EJML-80-293
June 10, 1980

Subject: Oyster Creek Nuclear Generating Station
Docket No. 50-219
NUREG 0578 Implementation

UPGRADE OF CONTAINMENT VENT
AND
NITROGEN PURGE SYSTEMS

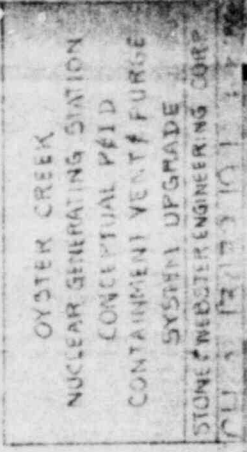
Oyster Creek uses its normal containment vent and nitrogen purge systems for post-accident venting and purging of the containment atmosphere. Since the containment penetration isolation valves are not single failure proof for the operation of these systems, JCP&L is proposing modifications to the systems as shown in the attached sketch (S&W 13432-19-1). There are three primary modifications proposed which include single failure proof valve manifolds for 1) containment vent line from drywell, 2) nitrogen purge line to drywell and 3) nitrogen purge line to torus. A secondary modification is being included to provide a flanged connection outside the reactor building, so that a portable supply of nitrogen may be connected in the event of a loss of the nitrogen tank.

Venting of the torus will be accomplished by using the drywell vent line via the torus to drywell vacuum breakers.

Each of the solenoid-operated valves (SOV) will be remotely operated manually from the control room. These new valves (SOV's) will isolate automatically on a containment isolation signal. Venting and purging will be manually initiated, as required, by controlled bypassing of the isolation signals. Each valve manifold will have two (2) independent power supplies. This is indicated by Division I and Division II on the sketch.

The manual valves shown are added to provide leak rate testing capability in accordance with 10 CFR 50, Appendix J.

UPGRADE OF CONTAINMENT VENT
AND
NITROGEN PURGE SYSTEMS

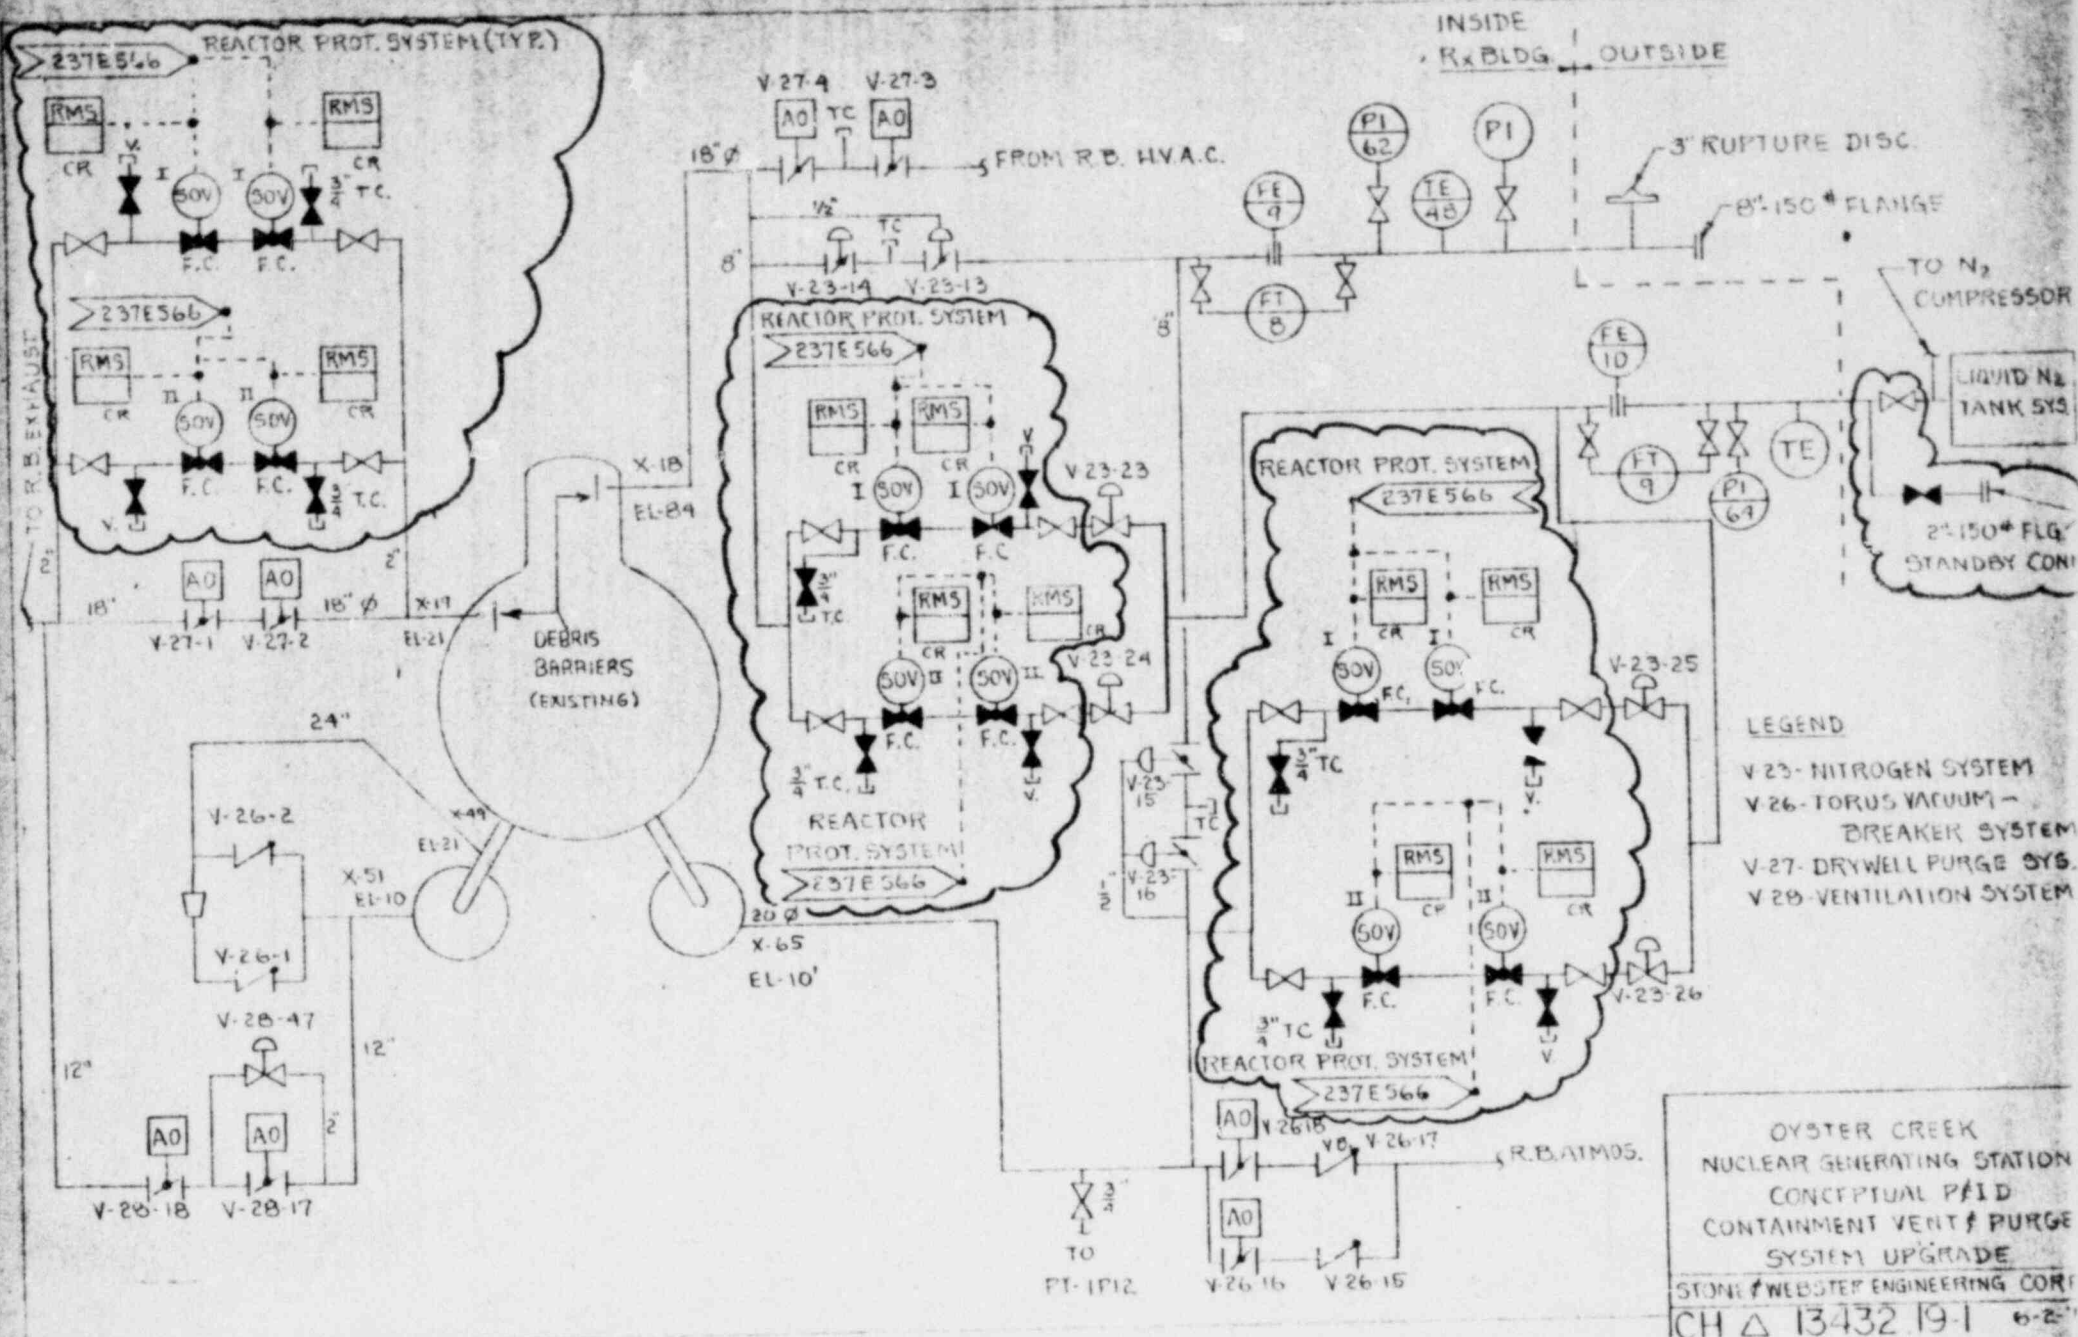
Oyster Creek uses its normal containment vent and nitrogen purge systems for post-accident venting and purging of the containment atmosphere. Since the containment penetration isolation valves are not single failure proof for the operation of these systems, JCP&L is proposing modifications to the systems as shown in the attached sketch (S&W 13432-19-1). There are three primary modifications proposed which include single failure proof valve manifolds for 1) containment vent line from drywell, 2) nitrogen purge line to drywell and 3) nitrogen purge line to torus. A secondary modification is being included to provide a flanged connection outside the reactor building, so that a portable supply of nitrogen may be connected in the event of a loss of the nitrogen tank.

Venting of the torus will be accomplished by using the drywell vent line via the torus to drywell vacuum breakers.

Each of the solenoid-operated valves (SOV) will be remotely operated manually from the control room. These new valves (SOV's) will isolate automatically on a containment isolation signal. Venting and purging will be manually initiated, as required, by controlled bypassing of the isolation signals. Each valve manifold will have two (2) independent power supplies. This is indicated by Division I and Division II on the sketch.

The manual valves shown are added to provide leak rate testing capability in accordance with 10 CFR 50, Appendix J.
